**State of Wisconsin**  
**DEPARTMENT OF NATURAL RESOURCES**  
 101 S. Webster Street  
 Box 7921  
 Madison WI 53707-7921

May 18, 2021

SUBJECT: Conditional Approval of Groundwater Extraction and Treatment System (GETS)  
 Interim Remedial Action Design Report (RADR)  
 JCI/Tyco FTC PFAS, 2700 Industrial Parkway South, Marinette, WI  
 BRRTS #02-38-580694

TOTAL PFOA AND PFOS PLUME EVOLUTION  
OVER TIME: DESIGN A

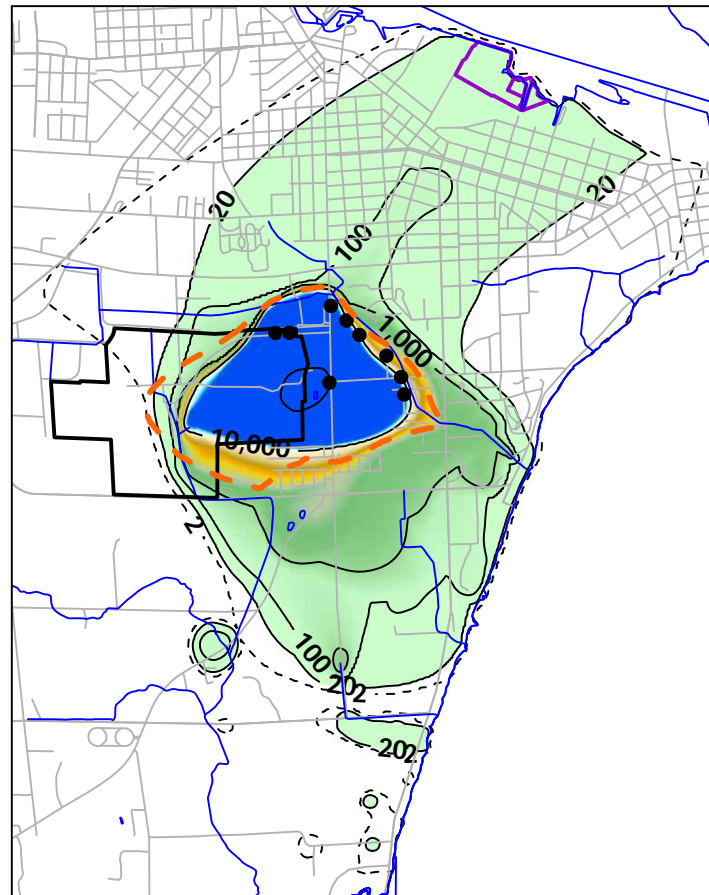
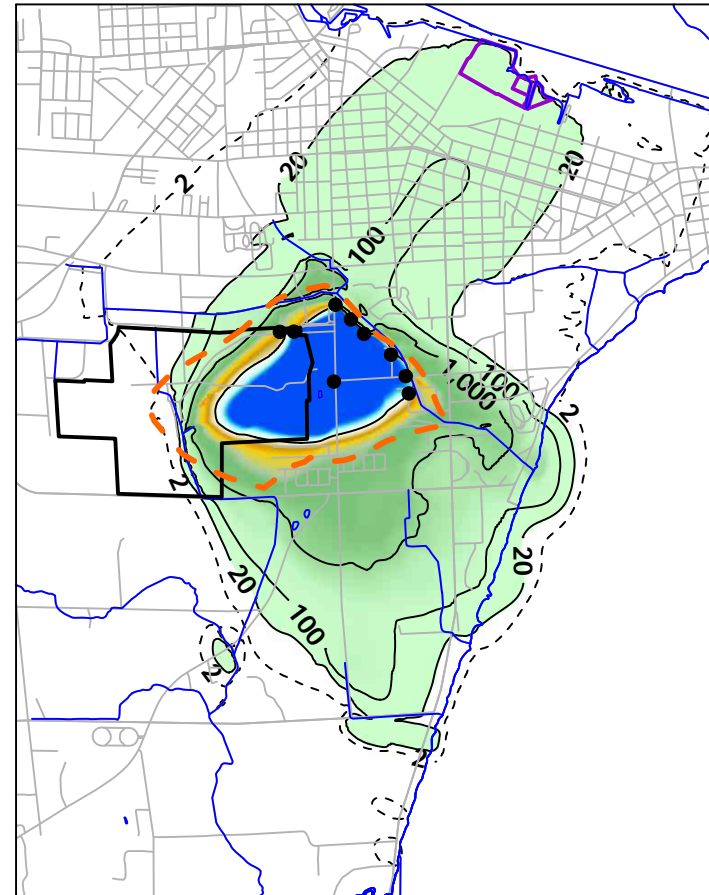
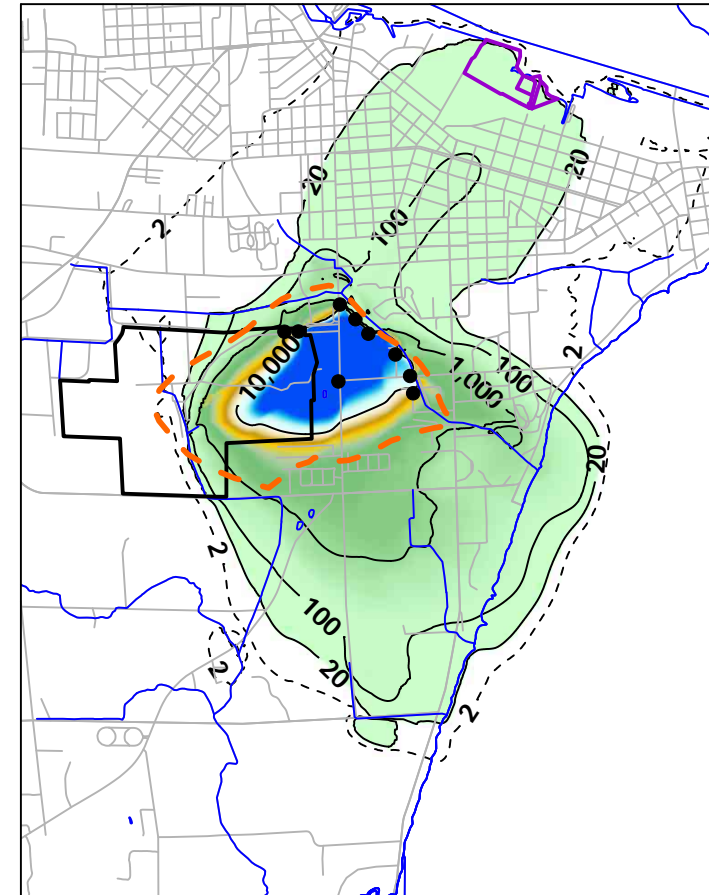
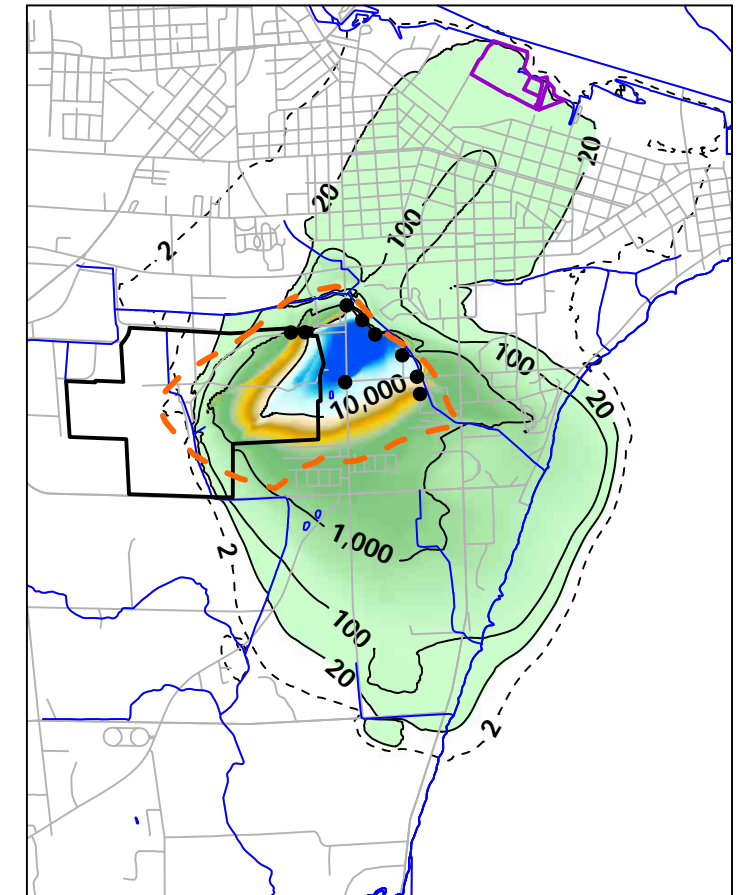
- The GETS is expected to reduce the PFAS concentrations in surface water in Ditch B as shown on Figure B-15 in the GETS RADR (**Attachment A**). JCI/Tyco will monitor surface water concentrations in a defined monitoring network.

FIGURE  
**B-8**

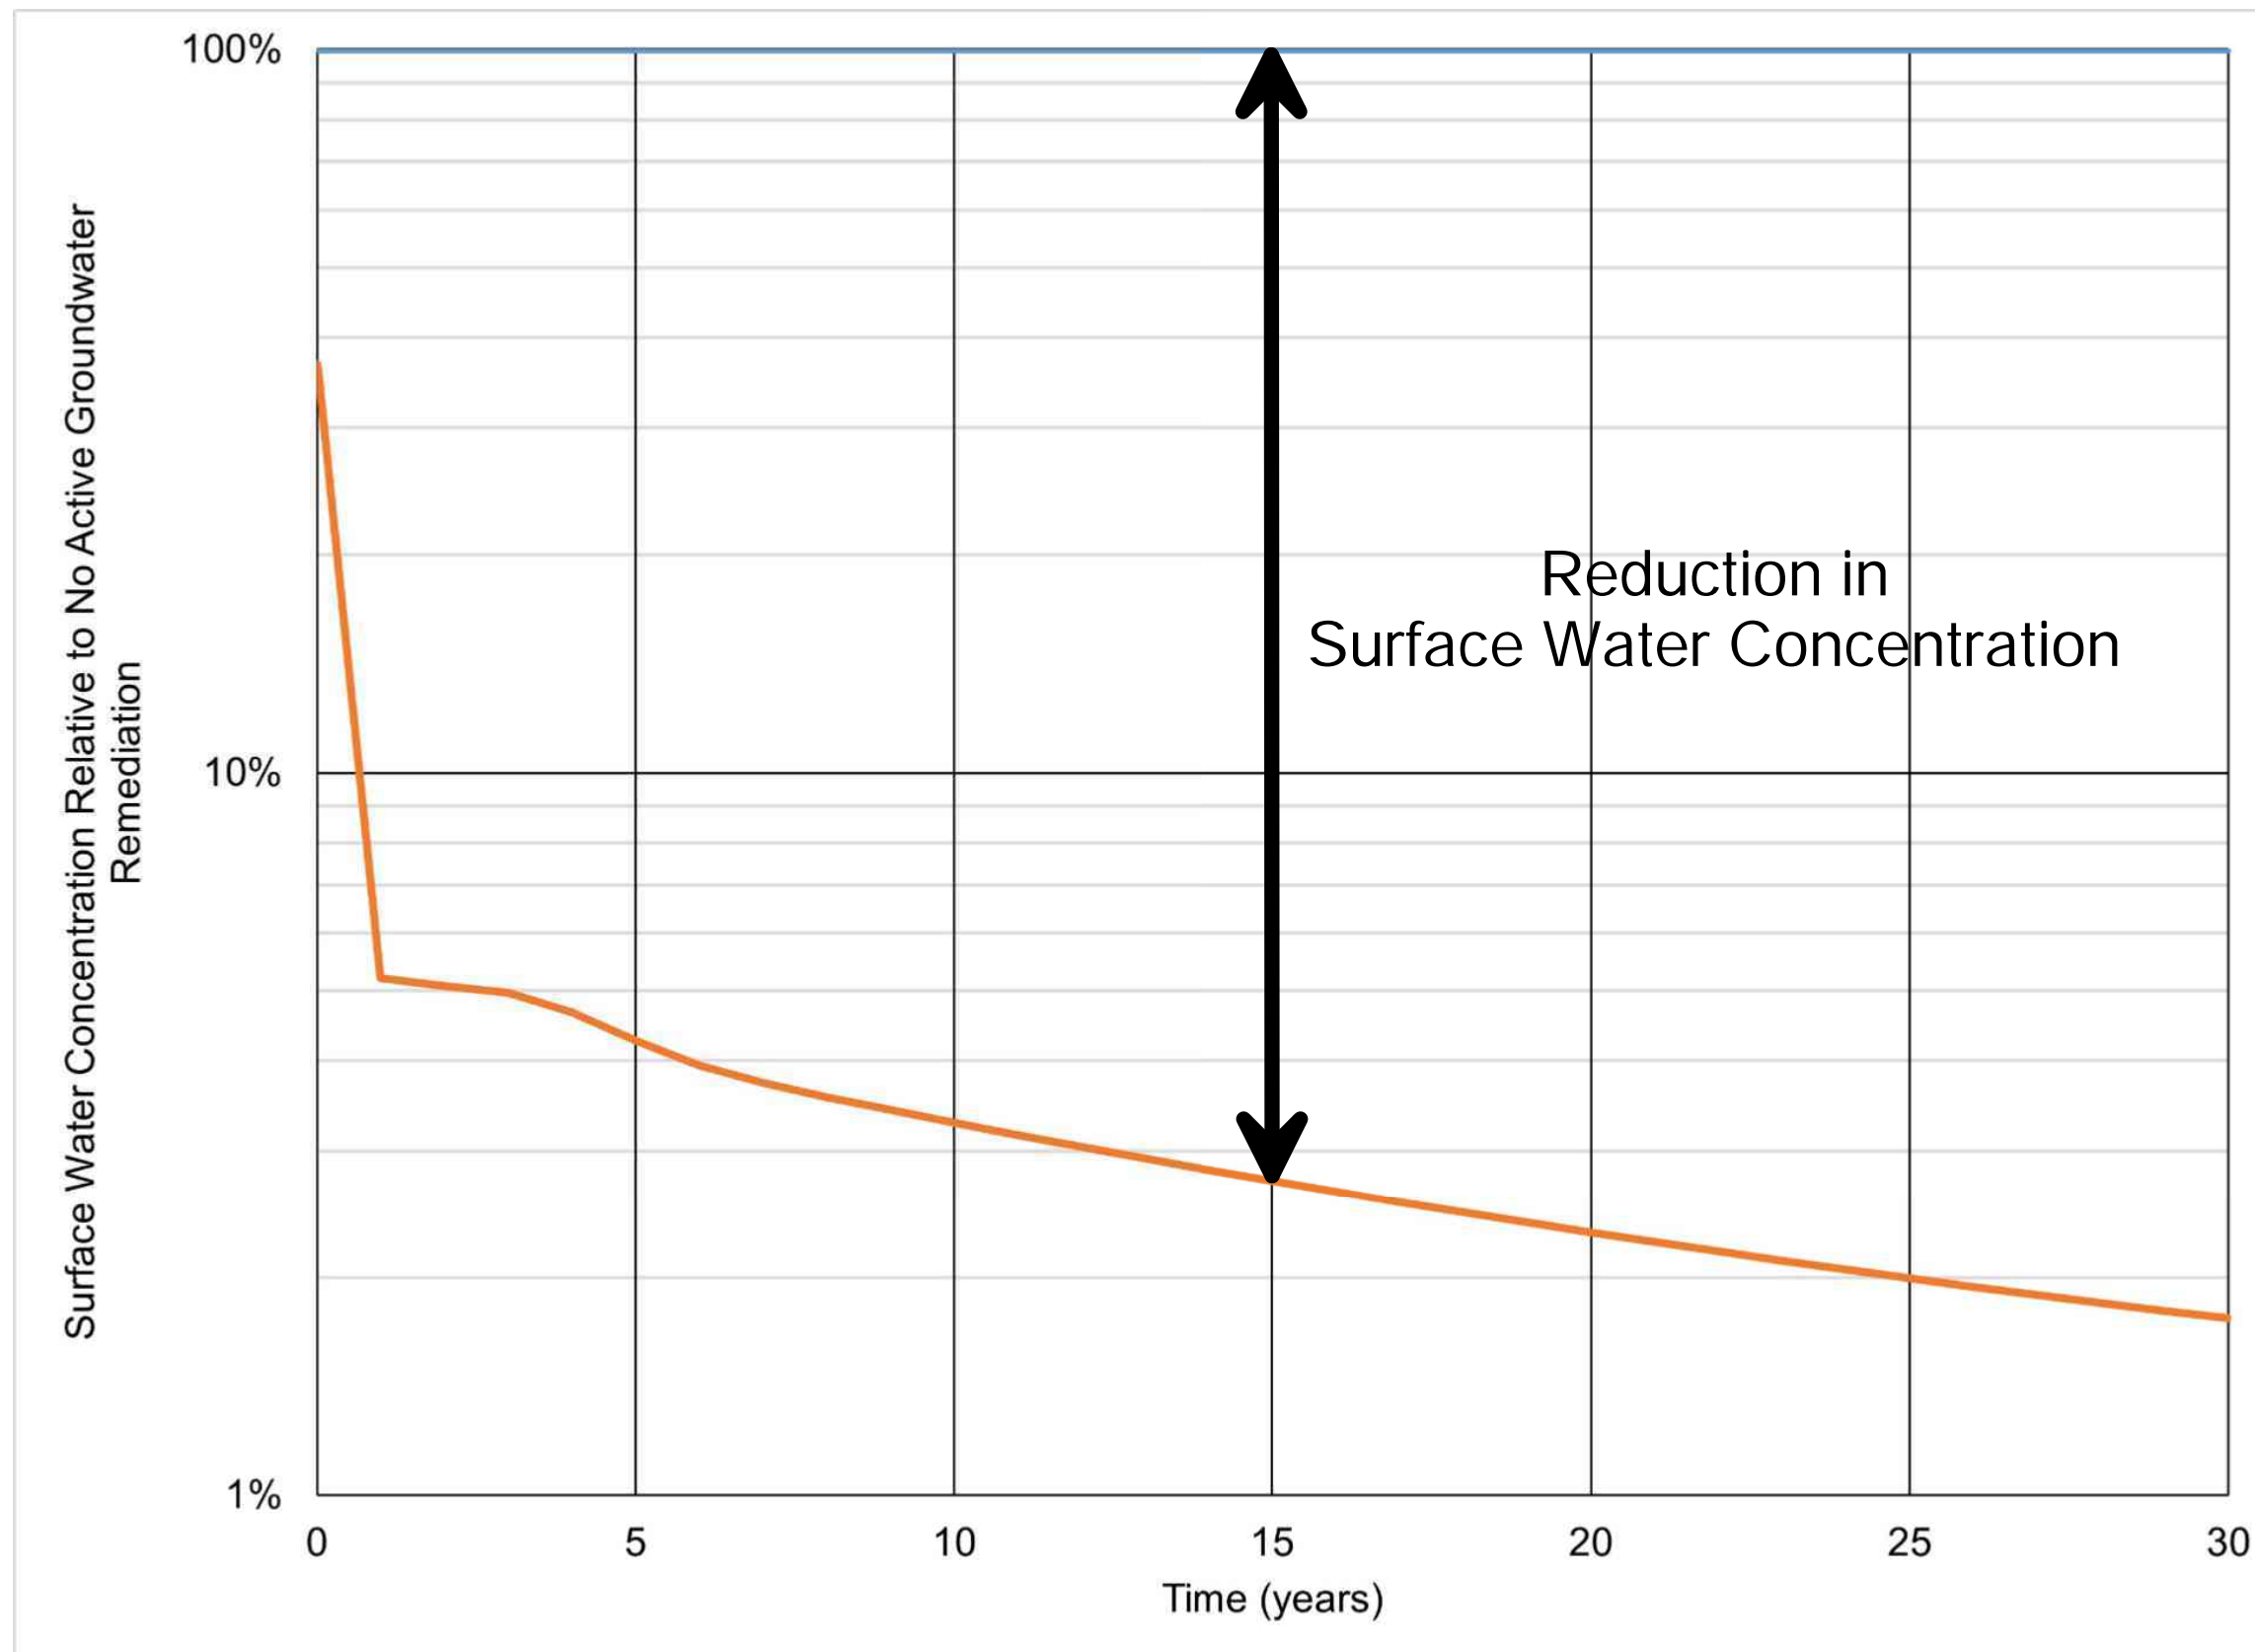
Using the current available data, JCI/Tyco concluded that groundwater with PFAS concentrations greater than 10,000 part per trillion (ppt) is present beneath and to the east of the FTC property (see Figure B-8 from the GETS RADR provided in **Attachment A**). Some of the contaminated groundwater upwells and contributes to the PFAS contamination detected in surface water in Ditch B, which then flows into the Bay of Green Bay in Lake Michigan. Based on these findings JCI/Tyco proposed an interim remedial action to pump and treat areas of highly contaminated groundwater that are migrating east from the FTC towards Ditch B.
